# SERVICE LETTER

No. 195

Piper Aircraft Corporation

Subject: Battery Cable and Rudder Cable Interference

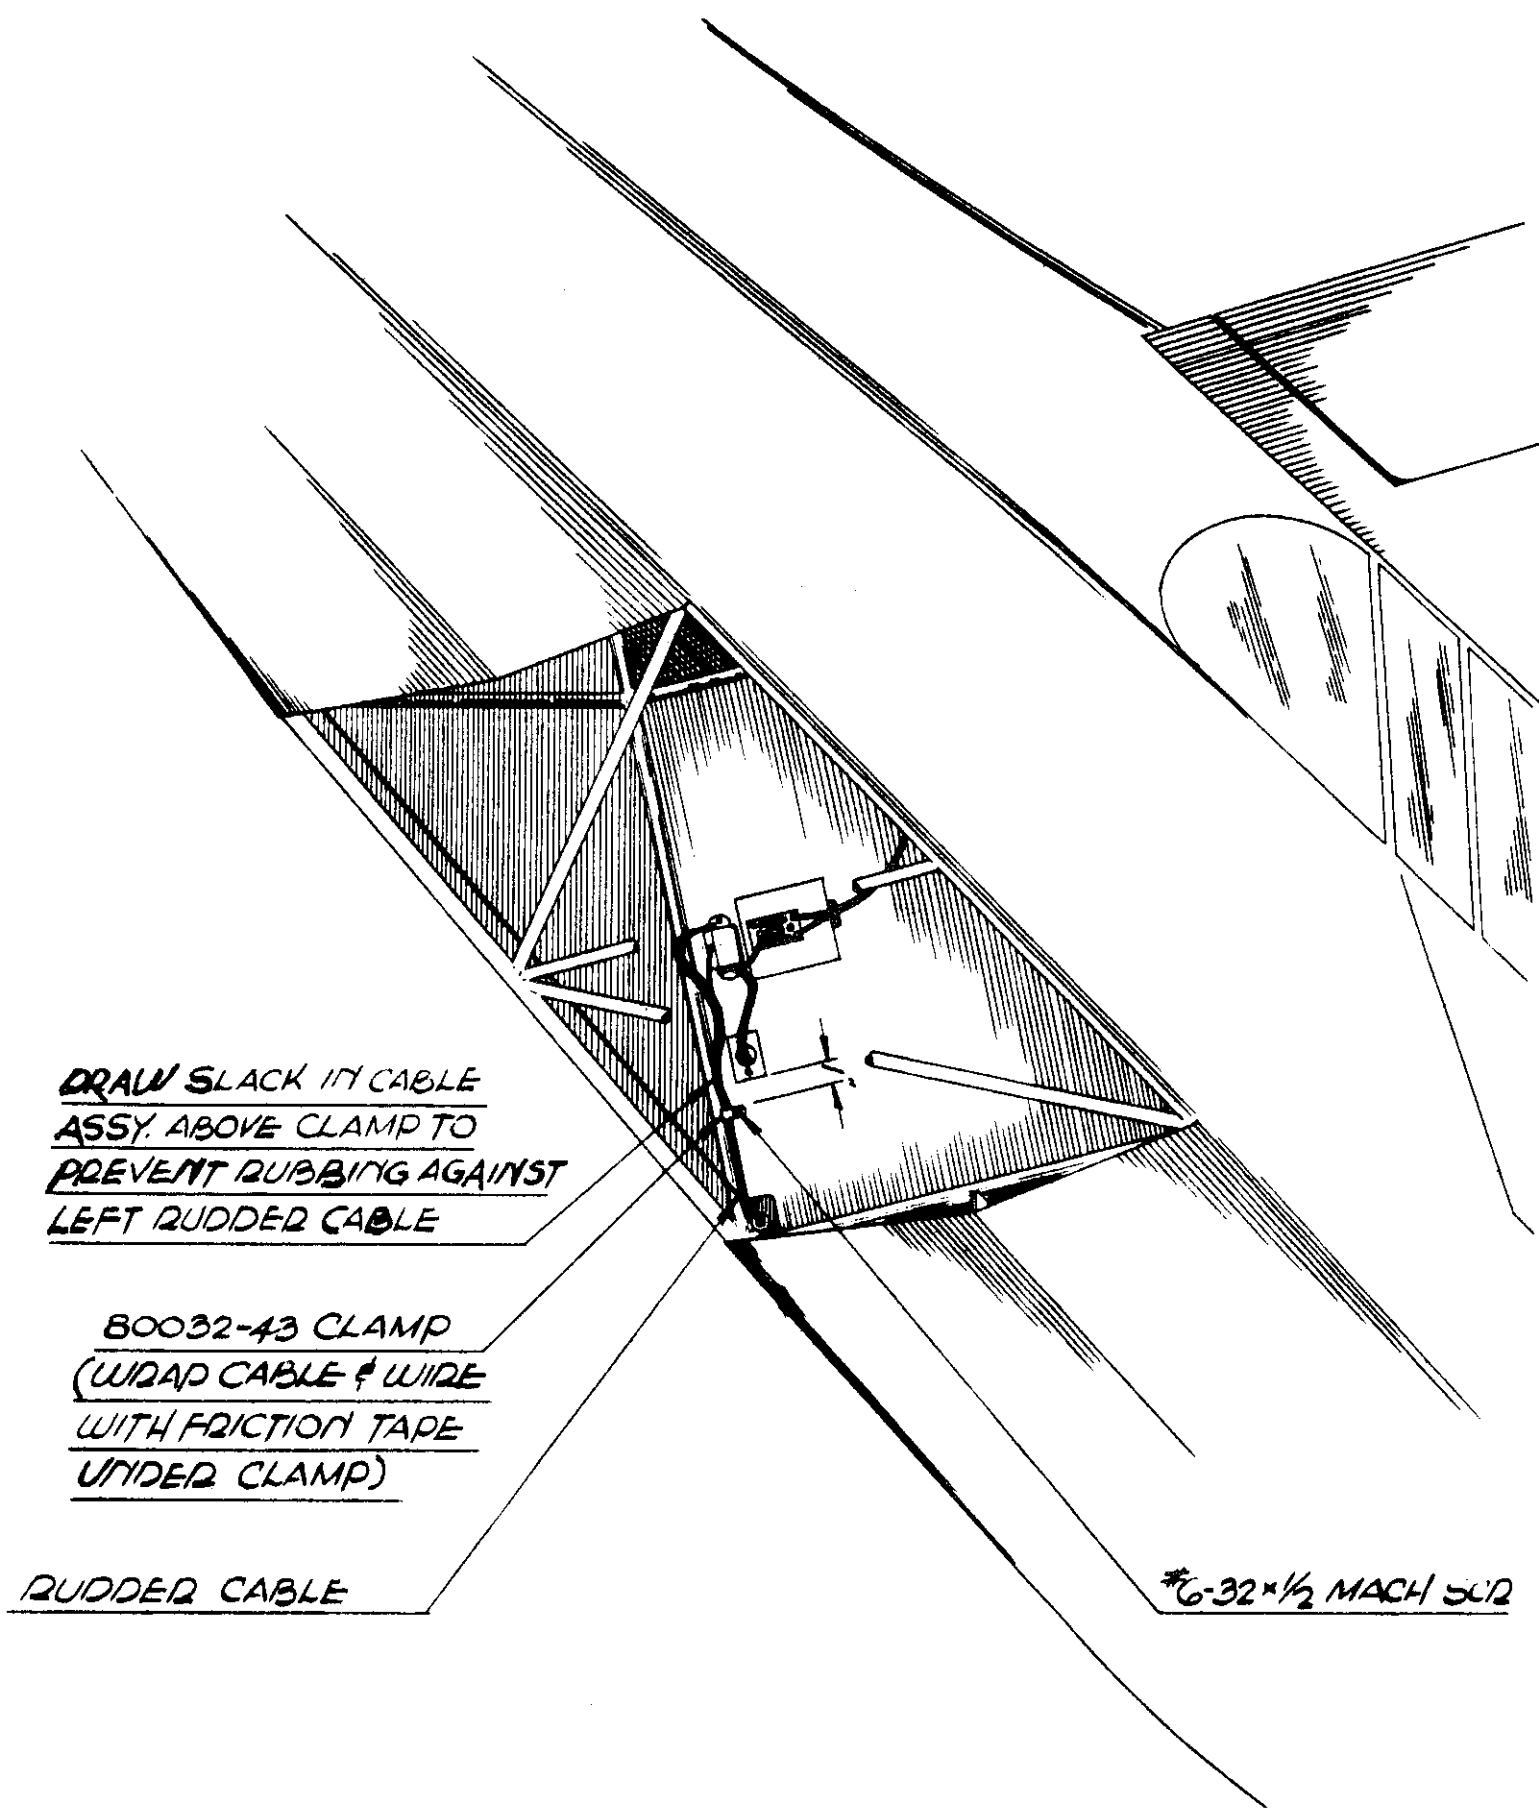
We have found there is a possibility of interference between the battery cable and the left rudder cable, back of the baggage compartment panel on the PA-18A Agricultural Airplane.

DRAW SLACK IN CABLE  
ASSY. ABOVE CLAMP TO  
PREVENT RUBBING AGAINST  
LEFT RUDDER CABLE

1. Remove the center belly panel.
2. Wrap the battery cable and solenoid wire together with friction tape, shellac, and install one (1) clamp, part number 80032-43, around the taped area and fasten it to the baggage compartment panel with a 6-32 x 1/2" machine screw, as per the attached sketch. Make certain that all of the slack is drawn out of the battery cable to prevent its rubbing the rudder cable.
3. Replace the belly plate.

B0032-43 CLAMP  
(W/AD CABLE & WIRE  
WITH FRICTION TAPE  
UNDER CLAMP)
